BAR Meeting
January 20, 2016

ISSUE: Certificate of Appropriateness (deferred items from 12/16/15 hearing)

LOCATION: 608 South Fairfax Street

UPDATE

Front Facade (West Elevation)

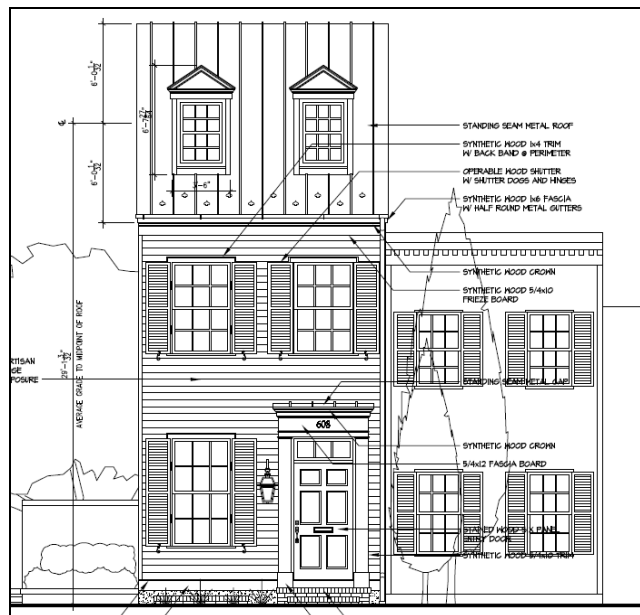
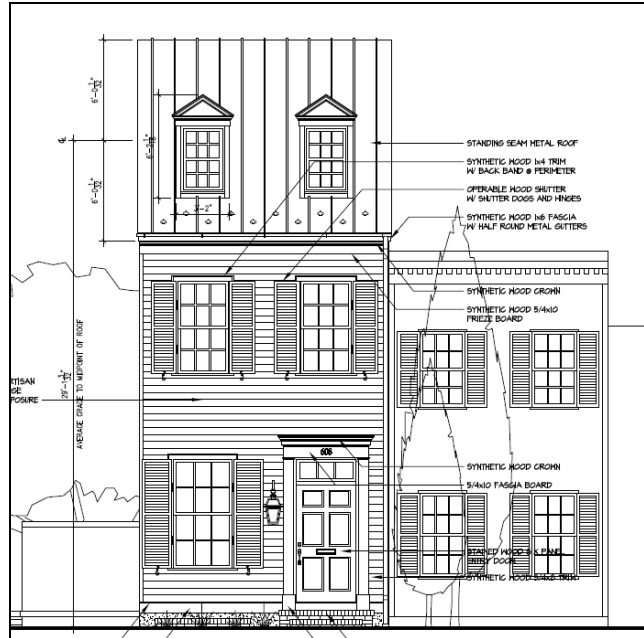
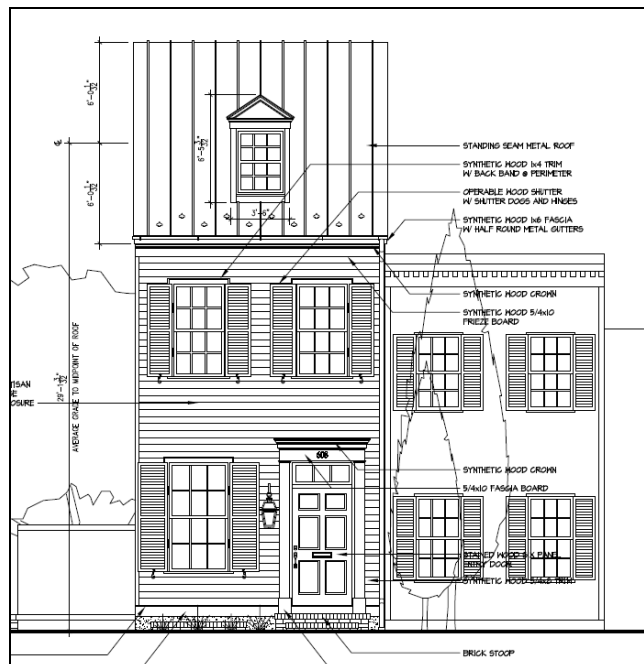
- More modest details on the front (west) elevation of the building, potentially including window muntins, simplification of the front door surround and the use of one dormer instead of two.

The entry door surround has been reduced in scale and detail. The width of the pilasters was reduced from 5/4x10 to 5/4x8, the header height was reduced by roughly 6", and the roof cantilever and secondary level of trim were removed. The width of the second floor windows was also reduced to create a tapering effect from the first floor up to the loft dormers in order to mitigate the column effect of the uniform window width shown in the previous iteration. The widths of the dormer trim and windows have been reduced.

Option B is the same as Option A, but with a single front dormer. This is the west elevation alternative recommended by staff.

In general, Staff supports the applicant's revised front elevation as it refines the contemporary Federal-styled details on the proposed new house. The simplified surround, as well as the progressively small window sizes, are elements commonly seen in the historic district. At the Board's request, the applicant also studied the possibility of a simplify muntin configuration on the windows, however, they prefer the retention of the six-over-six windows. Given the Federal Revival-style detailing on the house, staff agrees.

At the public hearing there was discussion by the Board about the appropriate number of dormers on the front façade. The applicant strongly prefers the two dormer option (Option A) and feels that the reduction in width of the second floor windows and the reduction in height and width of the dormers serve to balance the design and alleviate any concerns about "oversized" or "jumbo" dormers. Staff much prefers the single dormer, as it is more consistent with the simple, vernacular houses in Old Town, and presents less third floor mass and a more balanced façade on this narrow 14' wide townhouse. Staff obtained a survey of the 14 block area of Old Town between Jefferson Street to King Street, and South Lee Street to South Royal Street, and there are 126 houses with front dormers. Of those houses, over 70% (89) had a single dormer configuration, while only 37 had two or more. The vast majority of the two-dormer homes were wider than the subject property, having three bays or more. Staff believes that the single dormer is more appropriate and helps to simplify and minimize this upper floor, which is intended to read as an attic or loft space from the street and not a full third story. Further, the single dormer is less prominent, helping to make the new townhouse more of a background building on the block-face.

1. Install a single dormer on the front and construct the north and south elevations referenced as Option B in the application drawings; and,
2. Include the following notes on all construction drawings that relate to ground disturbing activity, so that all on-site contractors are aware of the requirements:
 - a. Call Alexandria Archaeology immediately (703-746-4399) if any buried structural remains (wall foundations, wells, privies, cisterns, etc.) or concentrations of artifacts are discovered during development. Work must cease in the area of the discovery until a City archaeologist comes to the site and records the finds.
 - b. The applicant/developer shall not allow any metal detection or artifact collection to be conducted on the property, unless authorized by Alexandria Archaeology.

North Elevation

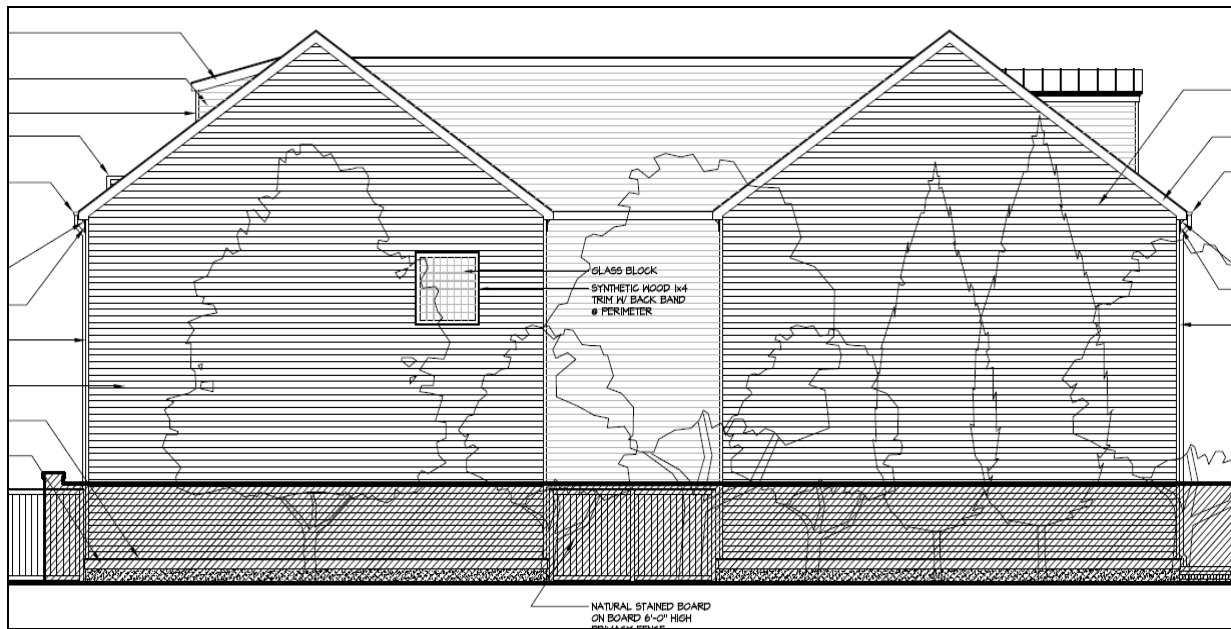
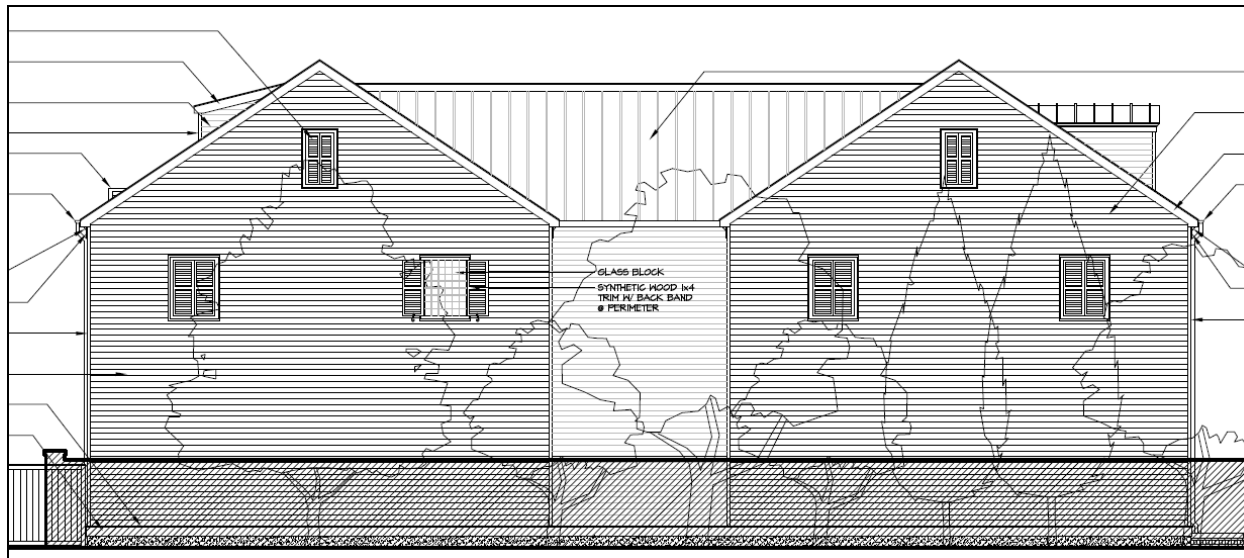
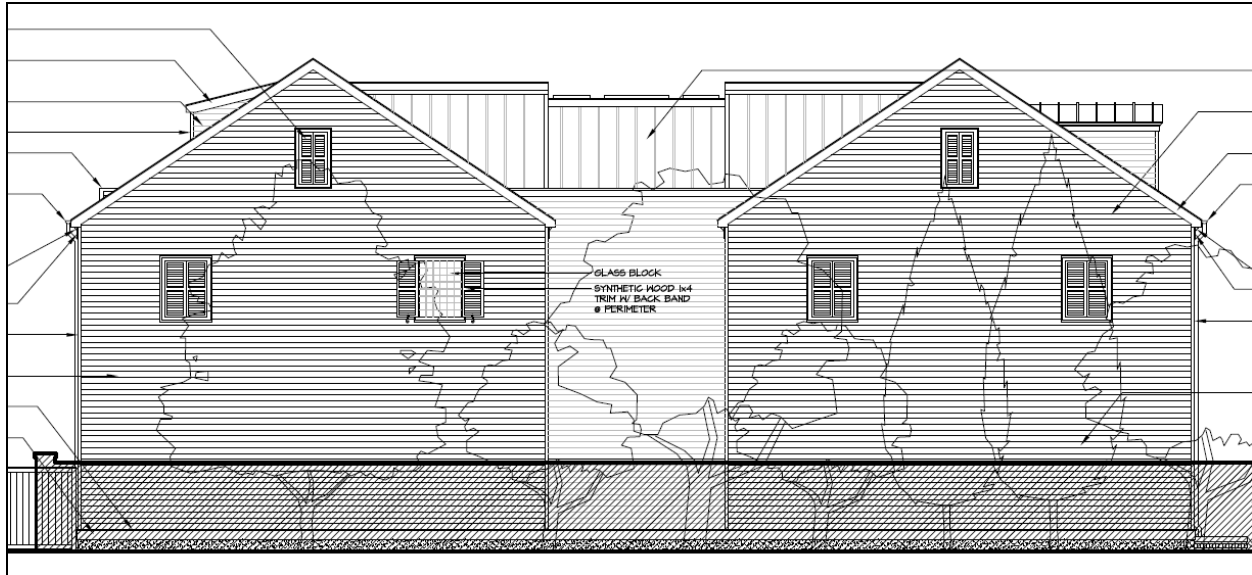
2. The approval is granted for the new dwelling with the exception of a restudy of the following two items:
 - The roof/wall geometry and materials of the third floor of the hyphen above the stairwell on the north elevation; and

Batten seemed metal cladding was added above the shirt board with Hardie-plank Artisan series lap siding below. Both materials will be painted a coordinating color (lighter) with the adjacent gable forms, which will be darker. False windows with closed shutters were added to the loft floors of the front and rear gable forms in order to add more detail and visual interest to the more prominent gable features and to allow the hyphen to remain a secondary background element.

The same false fenestration is proposed in Option B, but the middle portion of the very low sloped roof at the hyphen was lowered and flattened, and the skirt board was raised to visually minimize the third floor wall area. This flat central portion provides additional articulation at the skyline and is the north elevation alternative recommended by staff.

At the December hearing, the Board also deferred the portion of the north elevation relating to its roof/wall geometry and the materials of the third floor of the hyphen above the stairwell. The applicant explored a number of different options to modify the roof line and materials on the north elevation, but they found that changing the low slope roof form in the center section could create roof drainage problems on the adjacent property to the north, or would require routing the exterior pipes through the interior of the structure. In order to provide the Board some alternatives, the applicant has proposed two similar schemes (Option A and Option B). Option A retains the previously proposed overall roof form that was approved by the Board, while Option B provides a relatively minor relief in the middle portion of this hyphen roof form. While Staff has no strong objections to Option A, and this portion of the wall is set well back from the street behind a number of trees, it does not provide the articulation that some Board members were requesting at the previous hearing. While the variation in the ridge line in this alternative is minor, staff finds Option B to be the preferred elevation. Staff has no objection to the material changes or the addition of the blind windows on the north elevation, as they further reduce the visual scale of the wall.

South Elevation

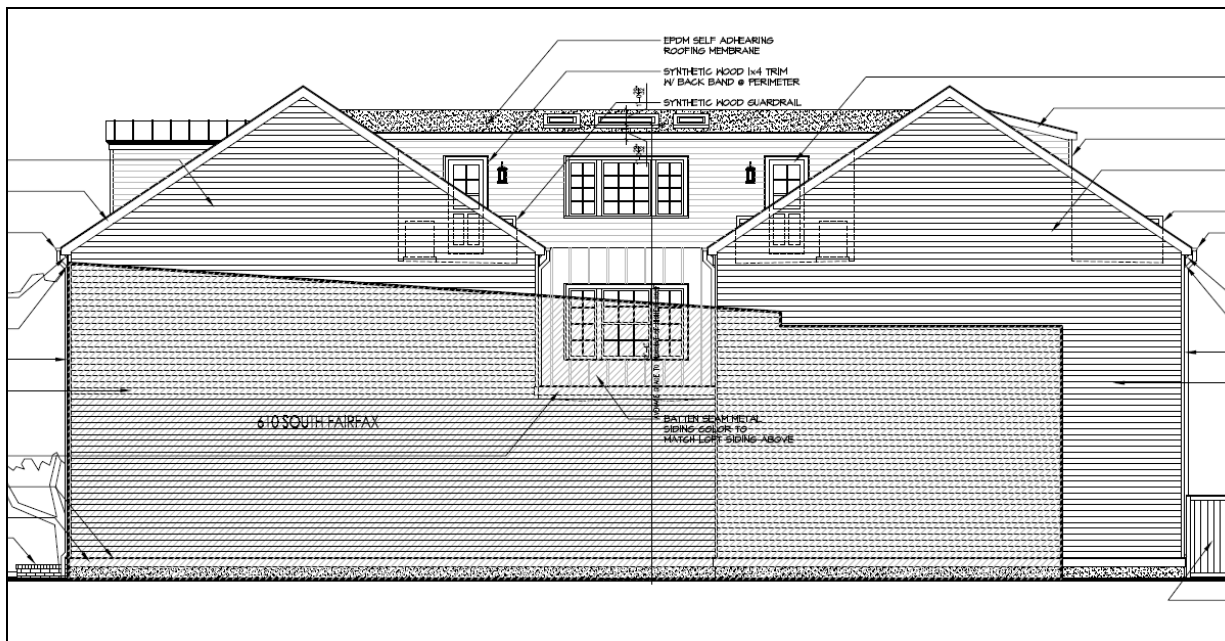
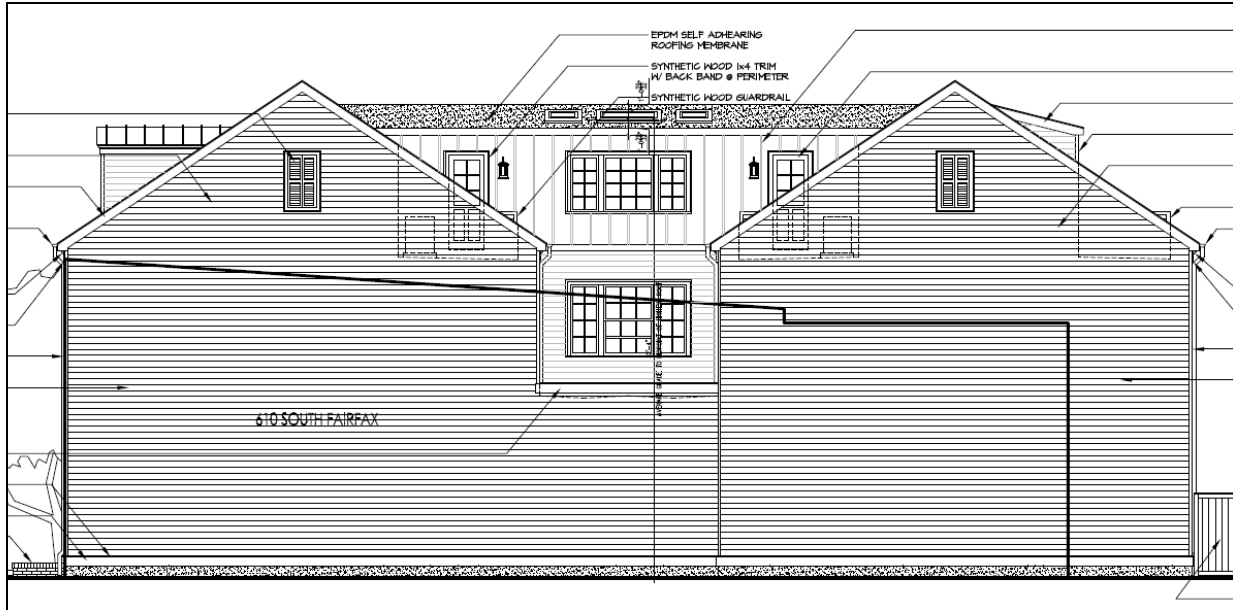
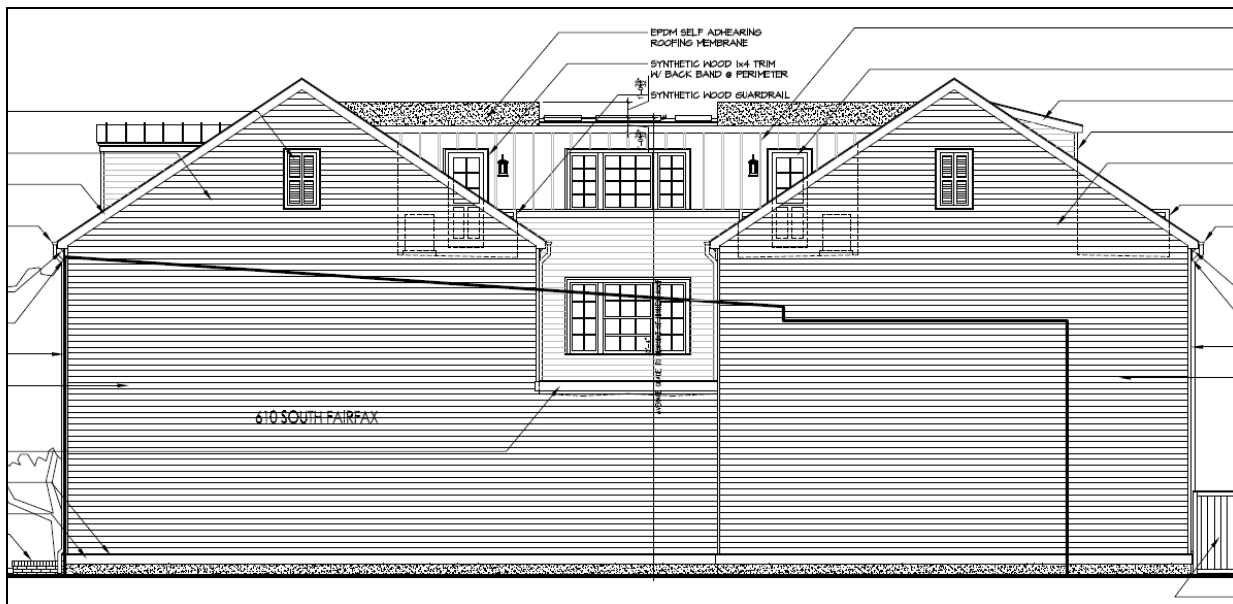
The batten seamed metal cladding was flipped from the prior proposal and added above the shirt board; while the Hardie-plank Artisan series lap siding was added below. Both will be painted a lighter coordinating color than the flanking gable end. False windows with closed shutters were added to the front and rear gable ends to provide more detail and visual interest to the more prominent gable features and allow the hyphen to remain a secondary background element.

The same false fenestration is proposed in Option B but the middle portion of the very low slope roof at the hyphen was lowered to have no slope and the skirt board was raised. This is the south elevation alternative recommended by staff.

While the south elevation will be minimally – if at all – visible from the right of way, minor changes were made to coordinate with the changes on the north elevation. Staff also prefers Option B on this elevation for the same reasons as noted above.
